## Staff Report for PLPR-2602-0001

**Application Type:** MU-I Planning Review

**Location of Subject:** 2029 Trinity Rd

# The Legacy Planning Submittal

**Zoning & Site Data**

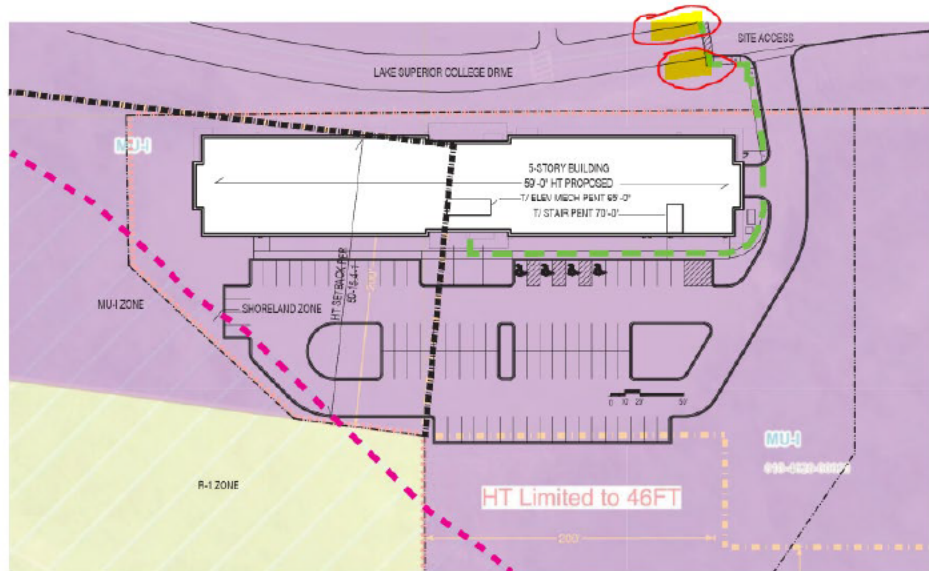
The DTA fully supports this project, and the housing is very much needed. For access to public transit and to encourage using the DTA, I'd ask that the sidewalks be extended 50' for a bus stop landing area on both sides of the road. If a shelter pad were constructed on the lower side, we could add a shelter in the future if ridership were high enough. Route 107 serves this location and connects people to the Mall Area, Lincoln Park, and Downtown.

11. One comment was received from the Duluth Transportation Authority, in support of the proposal. A request was made that 50 ft of sidewalk be included on both sides of Lake Superior College Dr to be used as bus stop landings. The DTA would then add shelter pad(s). A bus route serves this location and connects patrons to the mall, Lincoln Park and Downtown. The landings will allow residents access to and encourage the use of public transportation. This has since been incorporated in the plans.
